**MCPB
ITEM #17
10/28/04**

REVIEW TYPE: Preliminary Plan of Subdivision for 8 single-family detached residential units

PROJECT NAME: Briarcliff Meadows South

CASE NOS. 1-04036

Attachment 1

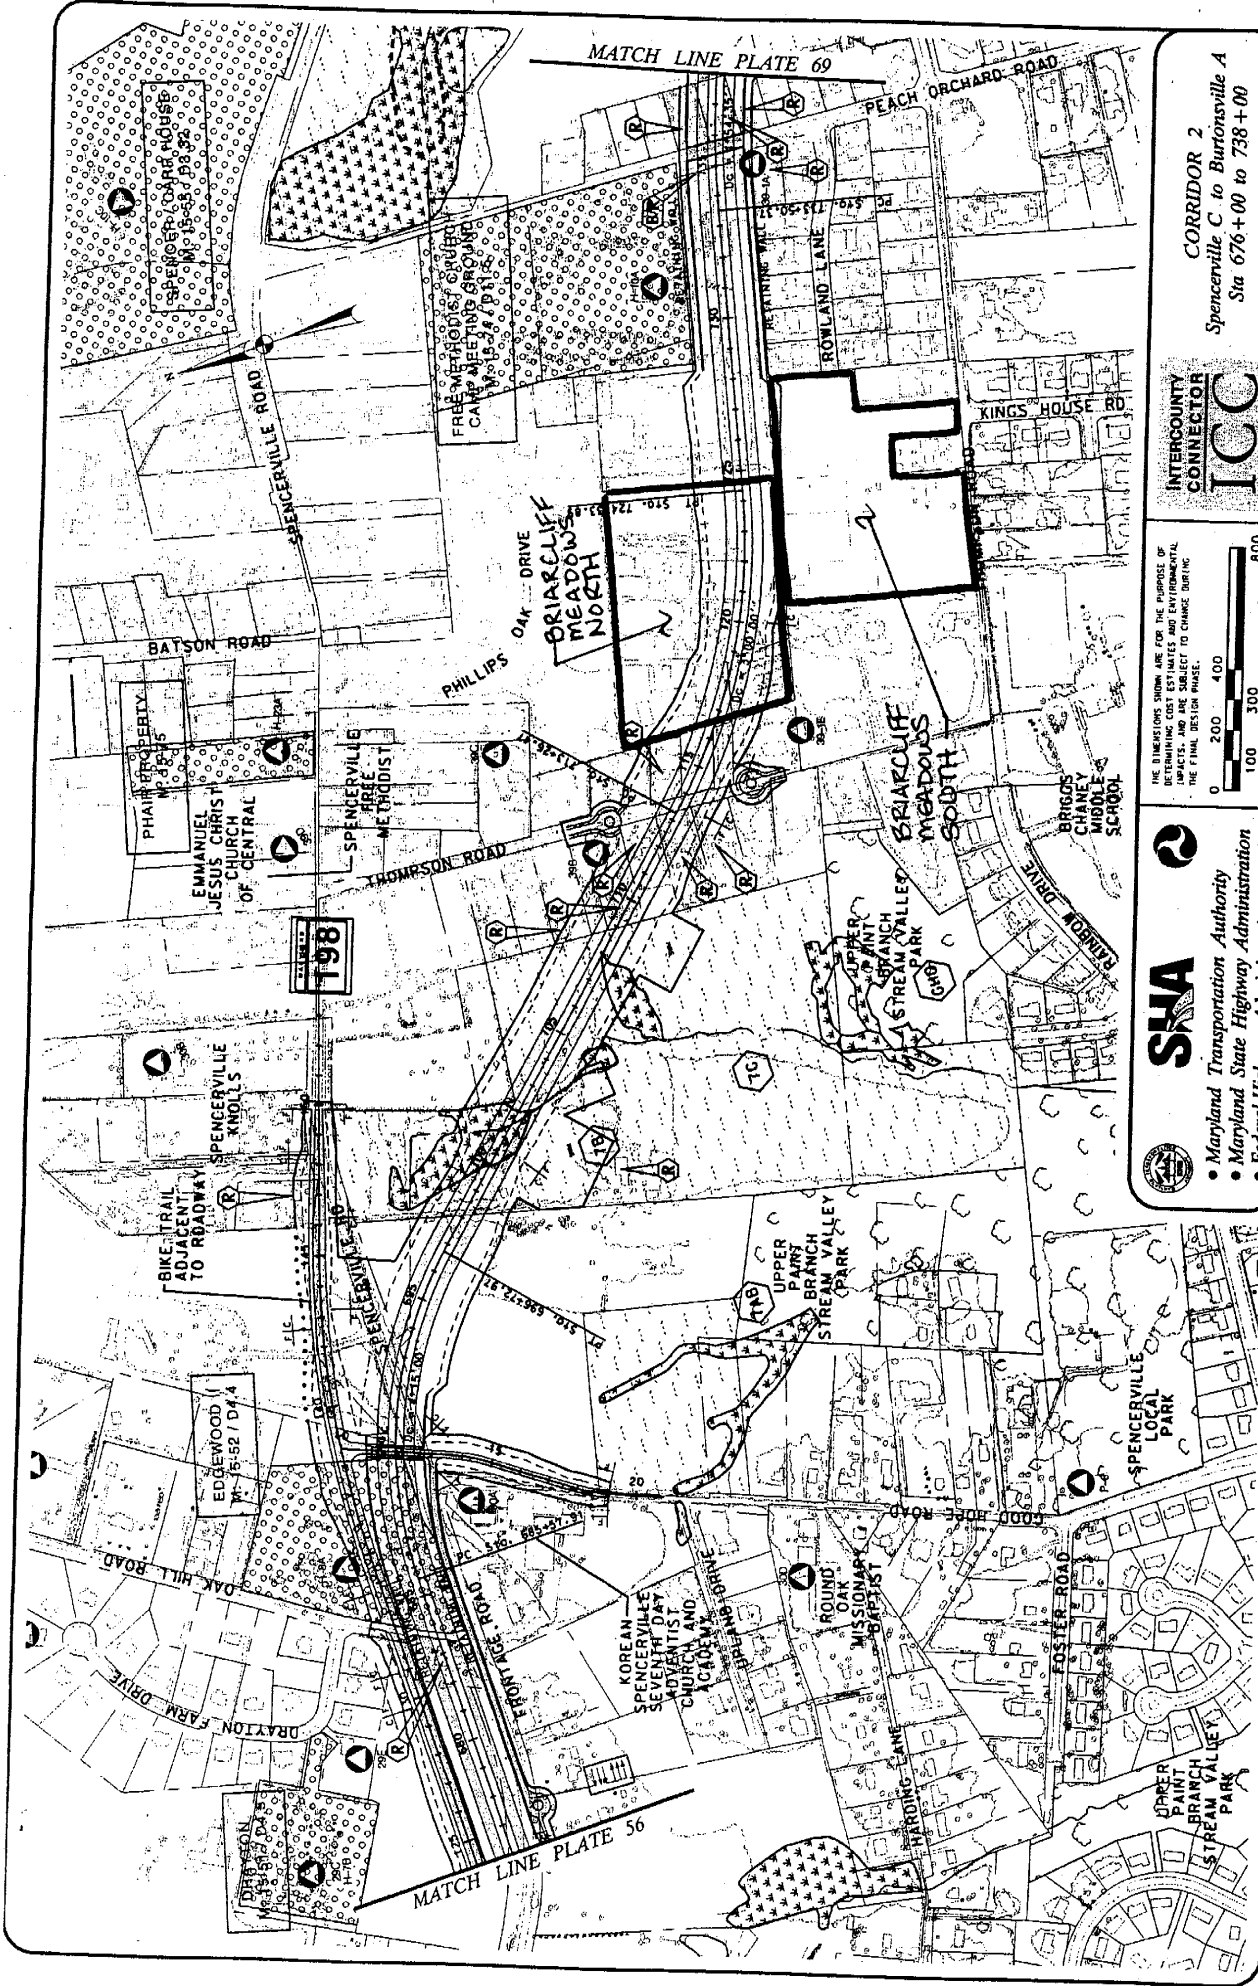
- 3) Any contract of sale between the applicant and any prospective buyer in the subdivision must (a) advise the buyer in writing that a reservation area as shown on Attachment 1, dated October 4, 2004 ("Reservation Area") is located adjacent to the subdivision; and (b) advise the buyer that they can contact the State Highway Administration for current information on the alignment within the Reservation Area. This notification requirement is binding on the applicant's heirs/successors and/or assigns.

The site is impacted by one of the optional alignments for the Intercounty Connector (ICC) currently under study as part of the Maryland State Highway Administration's (SHA) Alternative Retained for Detailed Study process (Attachment 1). As discussed below, the optional alignment abuts the northern property boundary of the subdivision. If the alignment were chosen, there may be direct grading impacts on the three lots proposed along the northern property boundary.

The ICC planning process has concurrence on two alternative alignments, selected through the Alternatives Retained for Detailed Study (ARDS) process, called Corridor 1 and Corridor 2. Corridor 1 is the southern alignment that generally follows the alignment incorporated in the area master plans for the ICC, and Corridor 2 is the alignment to the north that is not represented in any area master plans. Of the above two alternative roadway alignments, based on the most current information provided by the SHA, the Corridor 2 alignment would physically impact the proposed Briarcliff Meadows South development as shown on Attachment 1 and on Attachment 2.
